SERVICE INFORMATION LETTER NO. T-014
Page 1 of 4

1. SUBJECT: Generator Control Unit Relocation
2. MODEL: 480
3. EFFECTIVITY: Serial numbers 5001 through 5036
4. BACKGROUND:

Figure 1. Keel Access Panel Modification

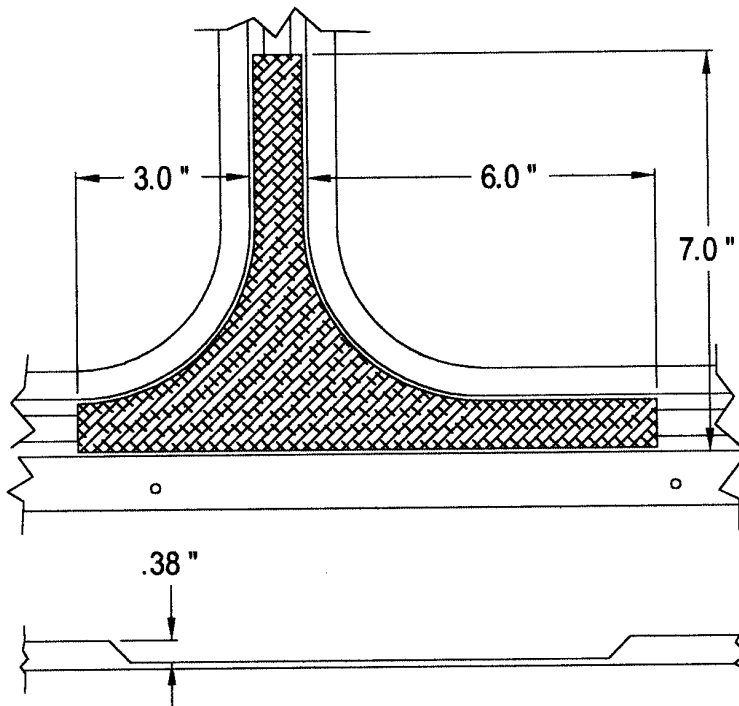
13. Reconnect the wiring to the T9 terminal strip.
14. Using cable ties and anchors, secure the wiring as required in accordance with AC 43.13-1B.
15. Using the fiberglass repair kit, modify the doubler on the right side keel access panel as shown in Figure 1.

1. Mark the location for modifying the doubler and using a suitable device cut out the excess material.
 2. Using either .125" balsa wood or foam sheet, fabricate a filler block for the doubler and bond into place using a suitable adhesive.

3. Apply two (2) layers of 6 ounce fiberglass cloth over the modification area using the fiberglass repair kit.
16. Connect the battery.
17. Ground run the aircraft in accordance with the Rotorcraft Flight Manual and check the operation of the GCU. Check/Adjust the voltage output of the GCU in accordance with paragraph 6-68 in the TH-28/480 Maintenance Manual.

MODIFY THE DOUBLER ON THE RIGHT SIDE
KEEL ACCESS PANEL AS SHOWN BELOW
